**Municipality of Anchorage
BOARD OF BUILDING
REGULATION EXAMINERS
AND APPEALS**

**DATE : August 4, 2005, 7:30 PM
Assembly Chambers, Z.J. Loussac Library
3600 Denali Street, Anchorage
Dave Paule, Chairman**

SUBJECT: Lot 7B, Block 2, Seaview Heights Subdivision
a.k.a. 6555 W. Dimond

RE: Permit No. 01-0076 – 6555 W. Dimond aka L7B, B2, Seaview Heights
Permit No. 00-6083
Change Order submitted May 03, 2005 and Comments

CROSS SECTION
LORI DR. (Center Line)
And DRIVEWAY

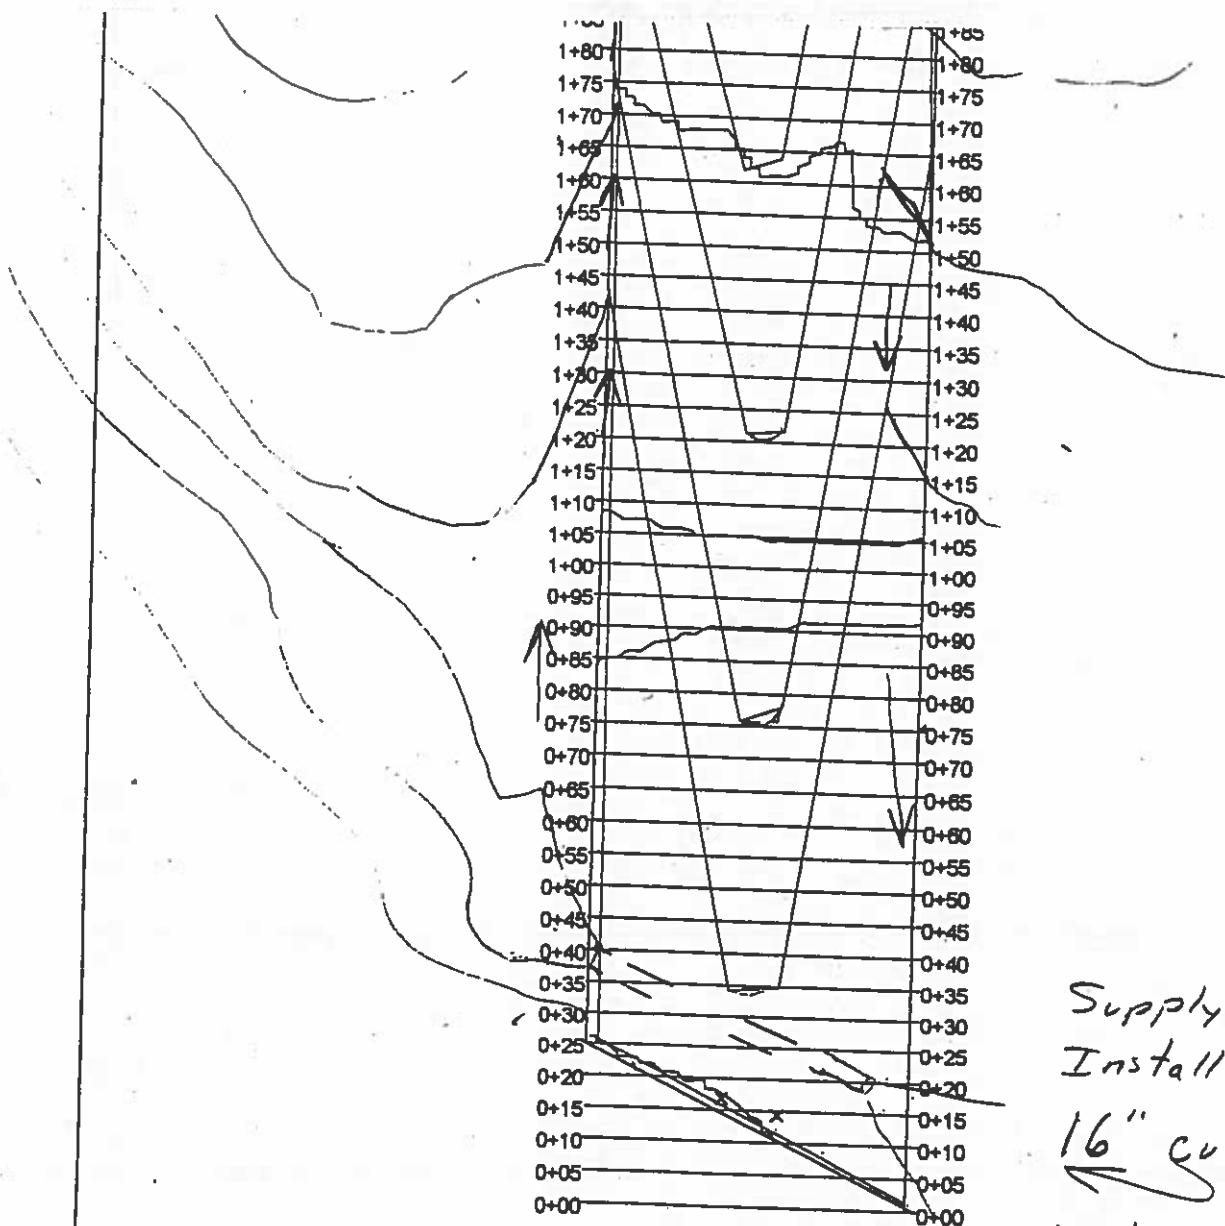
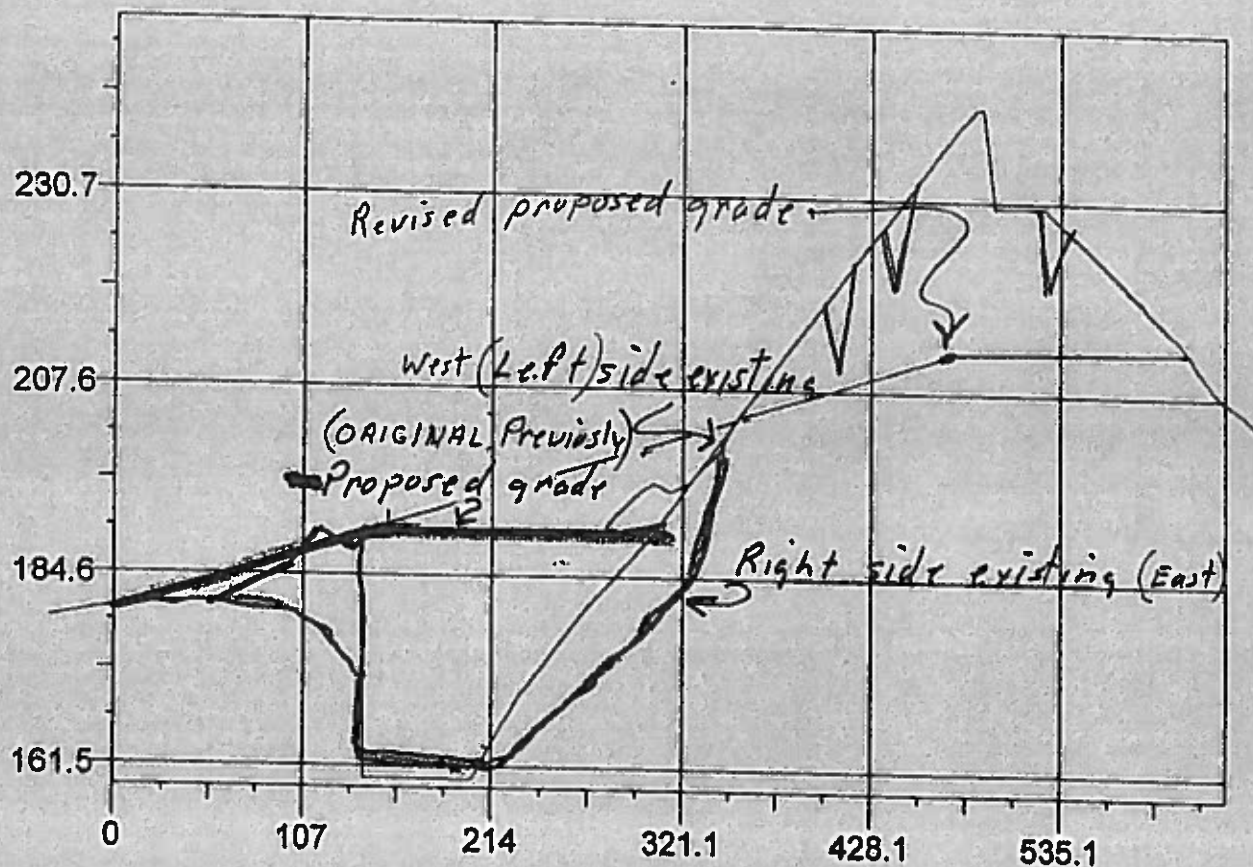
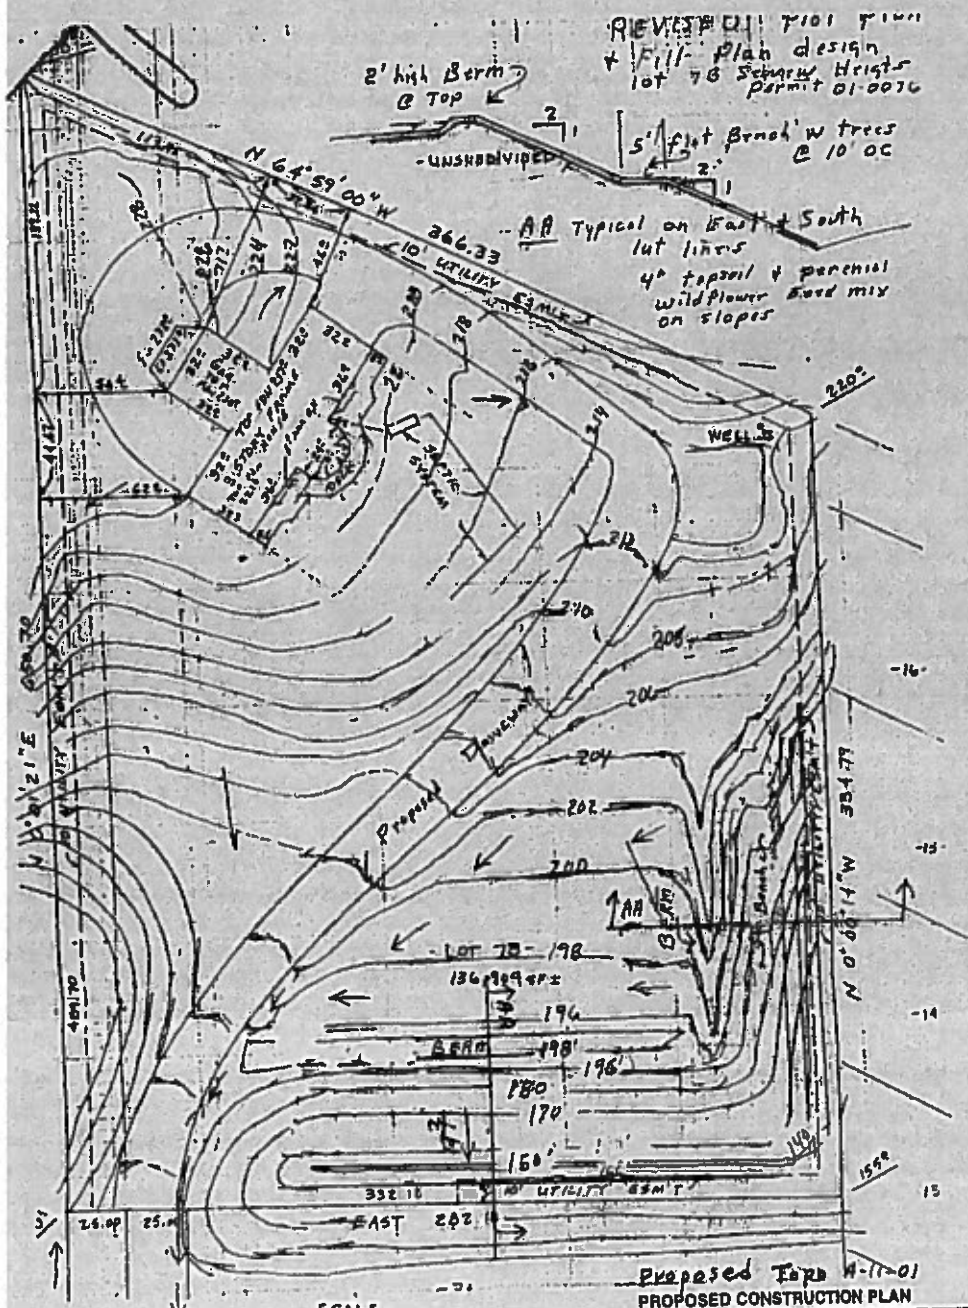
Requires PW/Stormwater review and approval.
Provide Engineering drawings w/ stamps and signature
DATE: 4-26-01 5-10 HRS: 05

4. Source of material: Any available, pending
5. Two site plans to scale showing limits: See attached with revisions
6. Cross sections to scale showing existing & final grades: See attached with revisions

Vally Rafter & Common Rafter Attachment to Attic Floor Diaphragm Detail

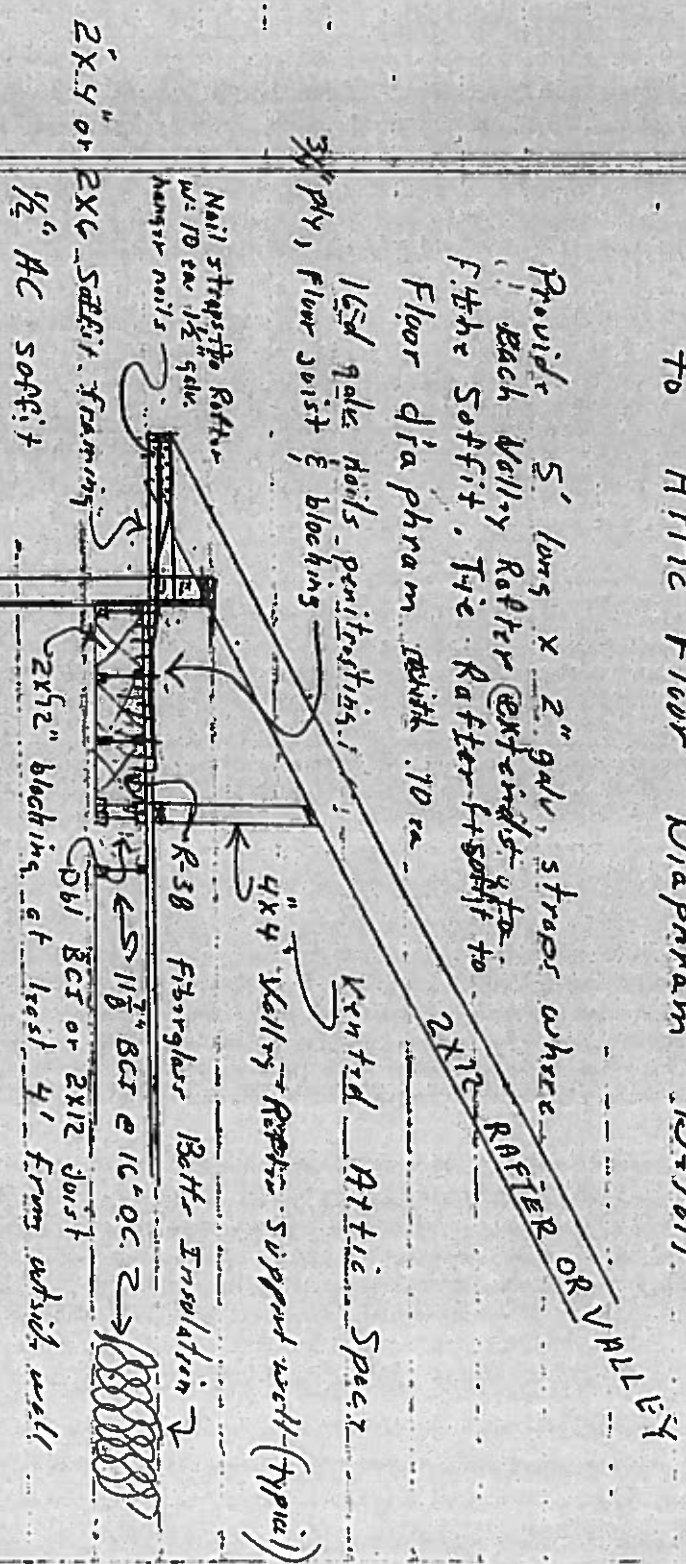
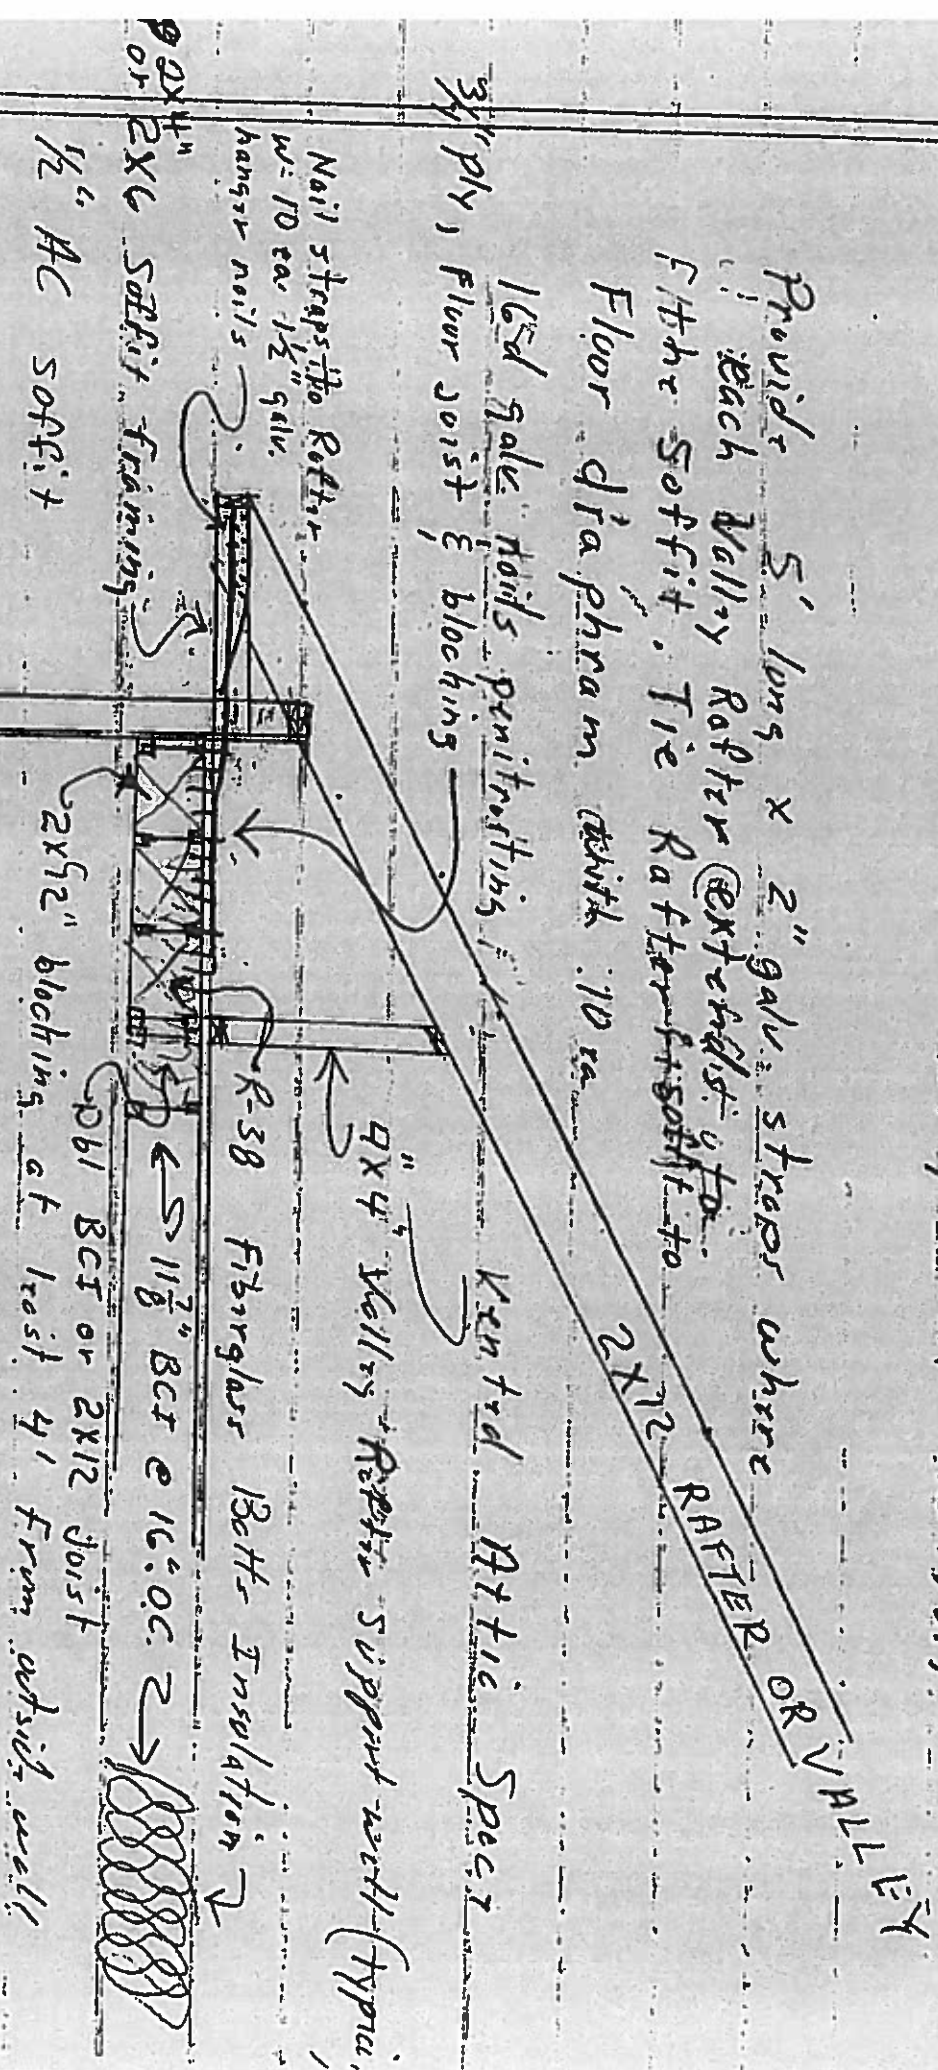
1. Roof Rafter Framing – The rafter framing of the roof. Rafter framing has been provided in place of trusses, but no design was provided. The load path for lateral forces must be defined, and calculations submitted to show the new load path is sufficient to transfer the required forces. 5-20-05 Information provided was reviewed. Information provide checked rafters at 24” o.c., it didn't look at the vally rafters or ridge beams, this can be seen by the loading that was shown in the calculations. One other statement was included that the floor diaphragm will act like a collar tie, the upper roof isn't even attached to the floor, it's attached to the inset pony wall. Response: The original design permitted included rafter framing through the main section of the master bedroom and entry foyer. This remains unchanged. This comment was

responded to Wayne Bolen in a letter dated 10-05-2004. It was also responded to in the 9/27/2004 Change Order request submitted which included a Temporary Shoring Plan. The floor diaphragm does act as a collar tie or bottom chord in that the 2 x 12 rafters extend out to the fascia at an elevation near to floor level where struts attach the fascia/rafters through the soffit to the floor sheeting. Change order drawing submitted 5-03-05. Valley rafters or ridge beams are shown on the drawing. See supplement "A" attached. BH comment "attached to inset pony wall" - Response: Incorrect - there are no pony walls. It is a full height wall from the lower level below extending through attic floor to support the 2 x 12 rafters. It is tied in to the attic floor diaphragm and therefore there is no hinge point created as there would be if it were a pony wall. There is no pony wall and this was explained to you during the 5-18-05 site meet while you reviewed the incomplete framing with the revised change order drawings.
